**ADDENDUM NO. 3**

**OMWD COURTYARD GARDENS PROJECT  
FOR THE OLIVENHAIN MUNICIPAL WATER DISTRICT**

September 23, 2022

DRAWN
CHECKED
DATE 8-3-22
SCALE 1"=4'-0"
JOB NO. 032-22-OMWD
SHEET L2
OF 6 SHEETS

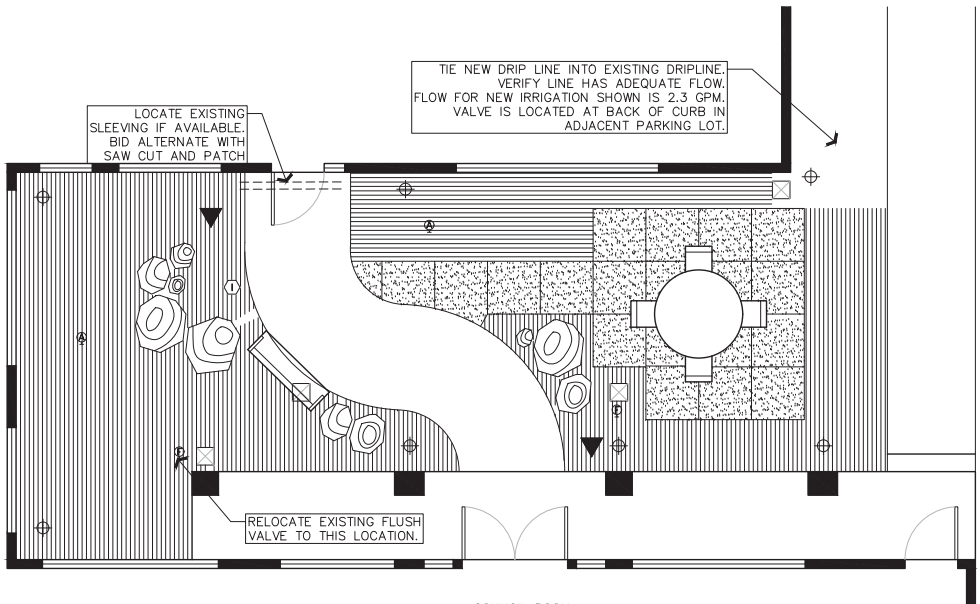
4. Q: Refer to standard note #8/ sheet L-1, quick couple valves shall be Nelson #7645 or Rainbird #44 np. However, irrigation schedule courtyards on sheet L-2 shows Buckner-Superior QB44AT-NP. Please clarify.

**A: Hunter ECO-ID is also used on recycled water system. Provide Hunter ECO-ID with reclaimed purple option per Detail B/L-3, item #8.**
7. Q: Refer to irrigation schedule courtyards, emitter EMT-6XERI is installed in 8" drip box. However, refer to detail C/L-3, item #5 is 6" round valve box with black lid. Please clarify.

**A: Provide quick couple valves in accordance with Recycled Water Standard Notes on L-1. See revised sheet L2.**
5. Q: Please provide detail of drainage chimney in plant pits as shown on planting specifications #16/ sheet L-6. **A: Drainage chimneys are not anticipated. If soil composition obstructs drainage, provide two 4-inch perforated pipes filled with 3/8" gravel for drainage as indicated on revised sheet L6. Drainage chimney will only be applicable to 24" box palo verde and 15 gal palm, if soil composition obstructs drainage. See revised sheet L6.**

**A: Provide minimum 6" diameter emitter access box with purple lid for recycled water. See revised sheets L2 and L3**

B ECO-ID

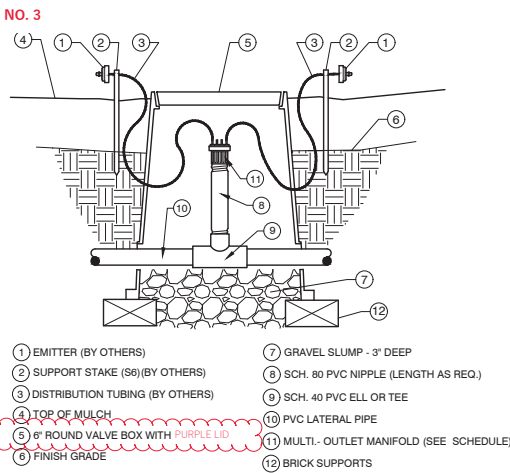
6. Q: Refer to irrigation schedule courtyards, indicator model is Hunter ECO-ID which is used in potable system. However, refer to detail B/L-3, item #8 is purple rubber cover. Please clarify.

COURTYARD PLANTING PLAN

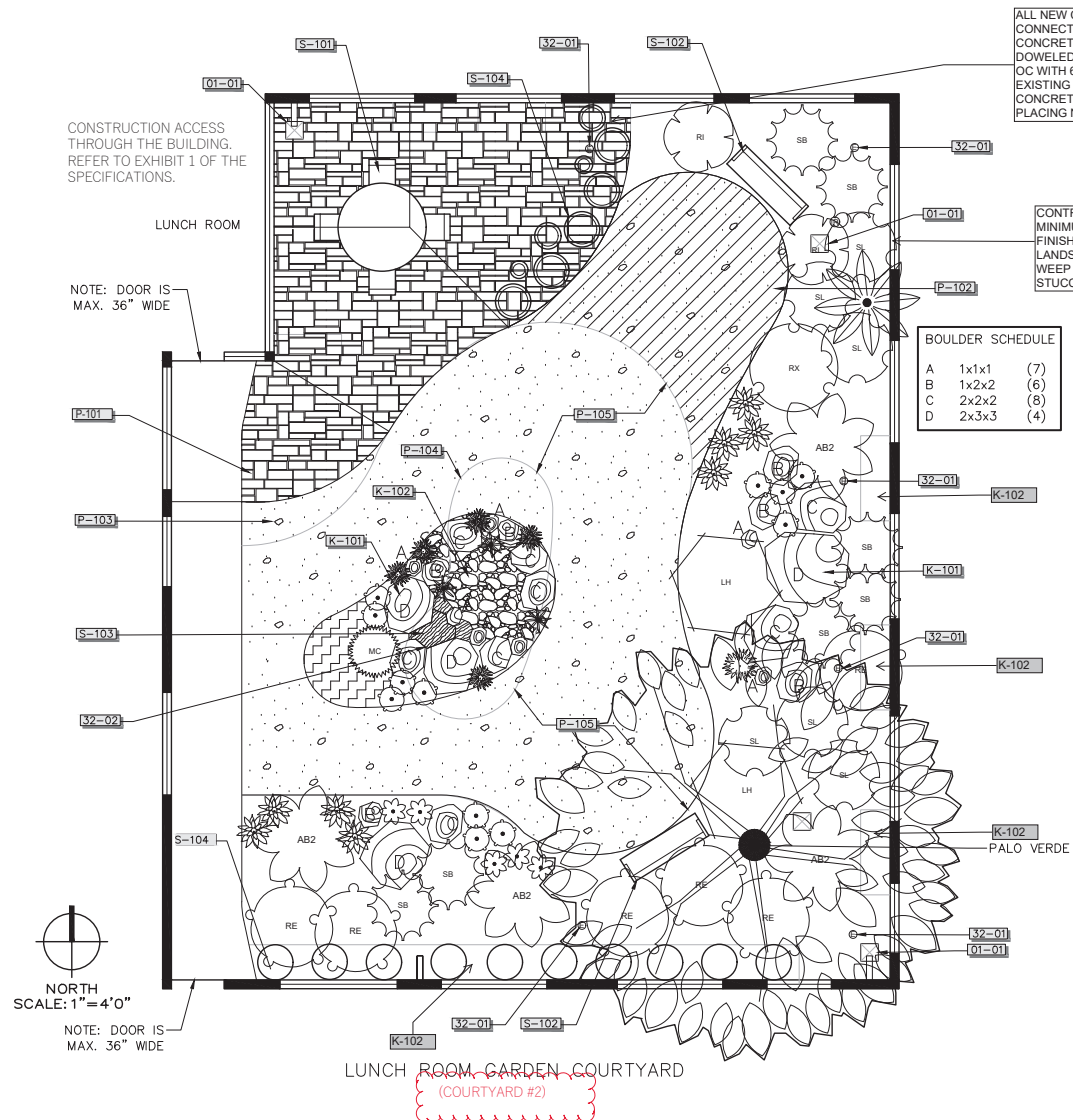
2. Q: Please provide specification for mulch material at planting area.  
**A: Provide planter mulch per OMWD Standard Specification Section 02900.**
3. Q: Please clarify limit of beach pebble mix, note K-102, shown on sheet L5.

9. Q: Please provide material and detail of decomposed granite as shown on reference notes schedule courtyards, symbol P-102.

10. Q: Please provide model and detail of black aluminum edging as shown on symbol P-101, sheet L5.

11. Q: There are no decomposed granite and beach pebble mix shown on plan courtyard #2, However, they are shown on base bid schedule B- revised (Courtyard #2). Please clarify.

12. Q: Please provide detail of concrete walk and patio, symbol P-101 as shown on sheet L5.

**A: For Lunch Room Courtyard, place beach pebble mix along exposed footing alignment. Provide 3-inch cover over concrete footing and 8-inch deep basin around perimeter of footing to create pebble band around footing.**

**A: Provide structural decomposed granite. Special resin/stabilization and color not required. Final selection to be coordinated with Owner during submittal process. All structural areas (i.e. non-planted areas) to be compacted to 90% relative compaction per OMWD Standard Section 02200. Planted areas to be compacted to 80% relative compaction, unless planting at existing grade. See revised sheets L5 and L6.**

**A: Provide 4" deep and 3/16" thick black interlocking aluminum edging and install per manufactures recommendations. See revised sheet L5.**

**A: Boardroom Courtyard is also referred to as Courtyard #1 and does not include scope for decomposed granite or beach pebble. See clarification to Drawing L5 and revised Bid Schedule previously issued via Addendum 1.**

**A: Refer to paving description on L5 for details of concrete walk and patio. Refer to Section 03000-3.17 for stamped concrete details.**
